Southern Metropolitan Cemeteries Trust  
C/- Urbis  
Attention: Kate Ryan  
Level 23, Darling Park Tower 2  
201 Sussex Street  
Sydney NSW 2000  
(sent by email only to kvryan@urbis.com.au)

30 May 2019

## **Additional Coastal Engineering Advice on Bumbora Point Cemetery Planning Proposal**

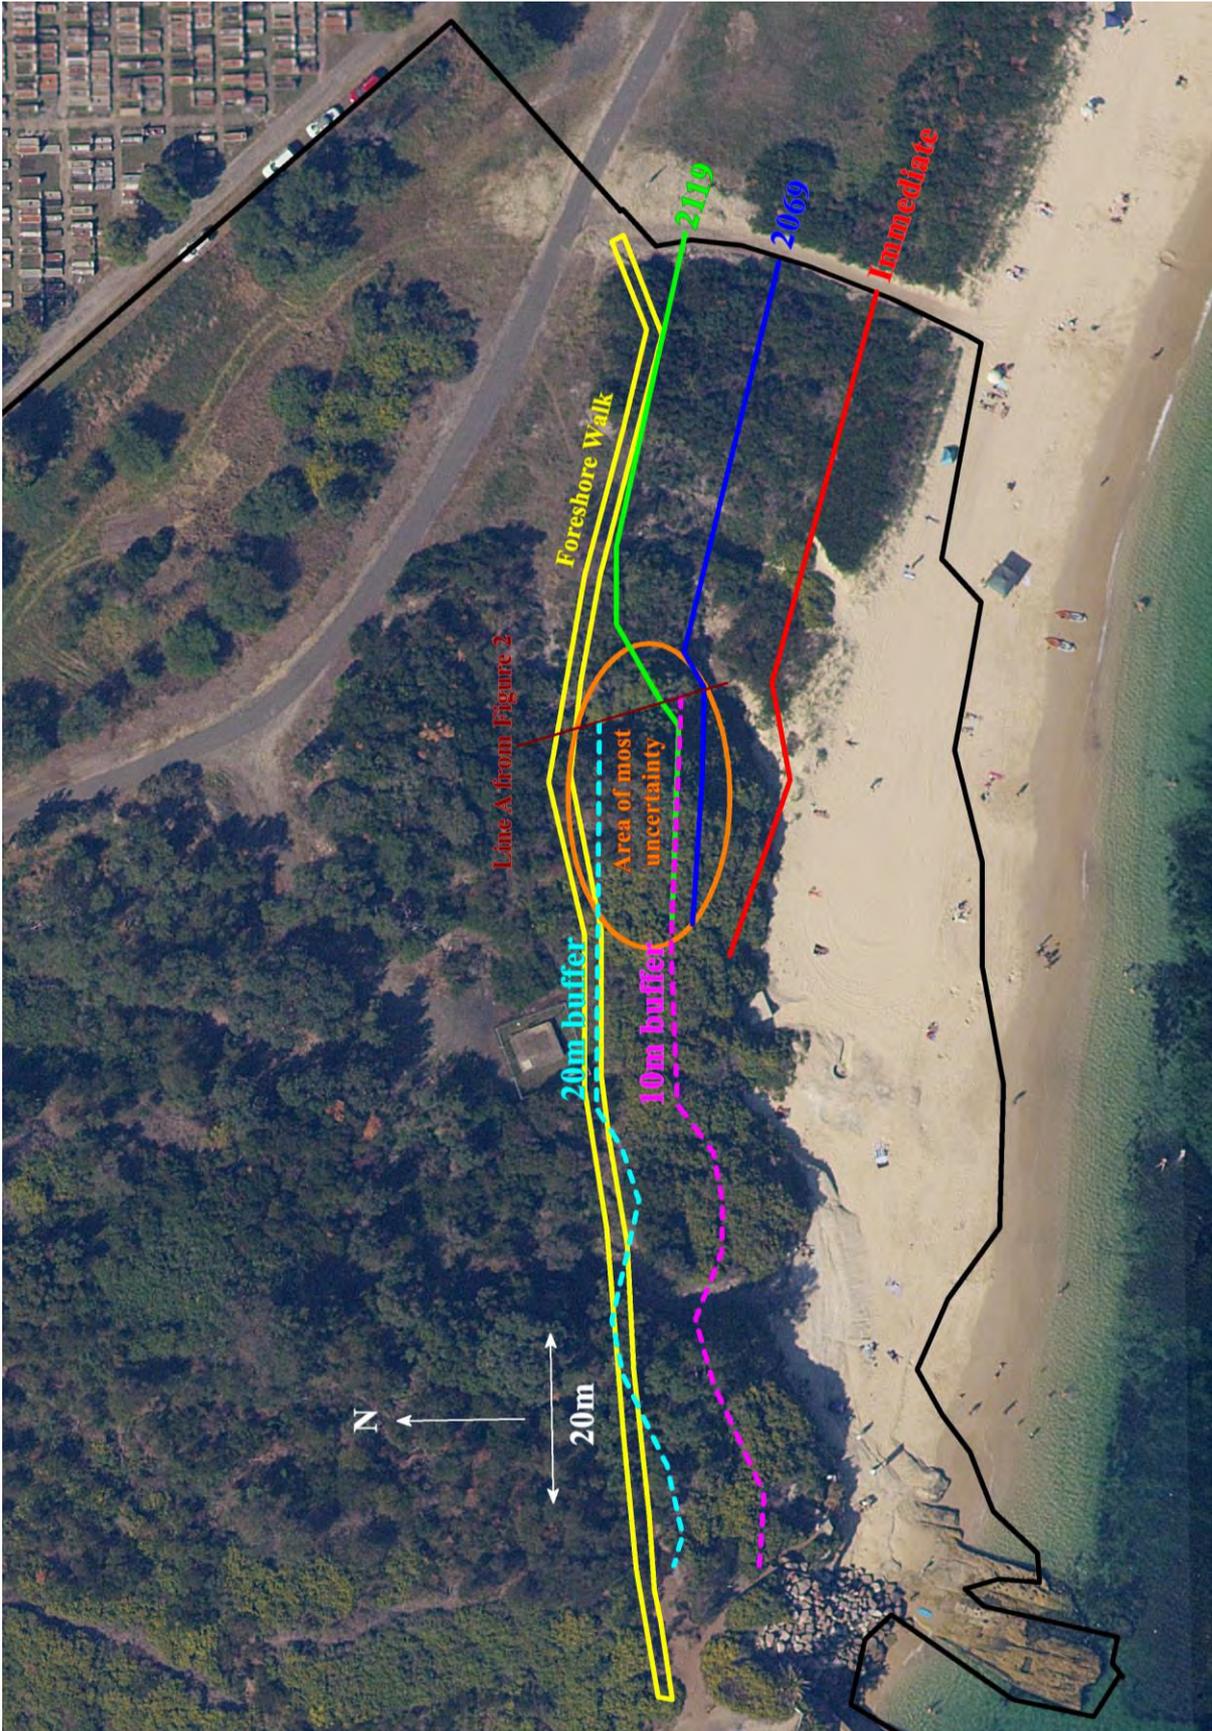
The Immediate, 2069 (50 year) and 2119 (100 year) hazard lines, considering adjustments for subsurface bedrock, are shown in Figure 3. The hazard lines within the orange-coloured ellipse in Figure 3 have the highest uncertainty due to no geotechnical testing results there, but the general trend of the lines is considered reasonable. Additional geotechnical investigations in this area would reduce the uncertainty, if required as part of future project stages.

Douglas Partners (2018) noted that a minimum setback for burials of 20m from the toe of cliffines was appropriate, with a reduced setback of 10m for ash interments. This is to allow space for natural attenuation of chemical and nutrient loading in groundwater, that is, to reduce the risk of contaminated water (seepage) from the cliff face. Douglas Partners (Sally Peacock, personal communication) also noted that a 10m to 20m buffer should apply from the high water mark in sandy areas, adjusted for long term recession. However, coastal hazards, rather than burial setbacks, govern in sandy areas. Approximate locations of these 10m and 20m buffers are shown in Figure 3.

It is evident in Figure 3 that west of Line A the groundwater buffers govern the required development setbacks, while east of Line A the coastal hazard lines govern. The proposed Foreshore Walk is depicted in Figure 3, which is the most seaward part of the cemetery development (that is, grave sites and ash interments are located landward of the Foreshore Walk). The Foreshore Walk (and hence cemetery development) is located landward of the 2119 Hazard Line, and the cemetery development is landward of the 20m groundwater buffer. The location of the Foreshore Walk and cemetery development is thus considered to be acceptable from a coastal engineering perspective.
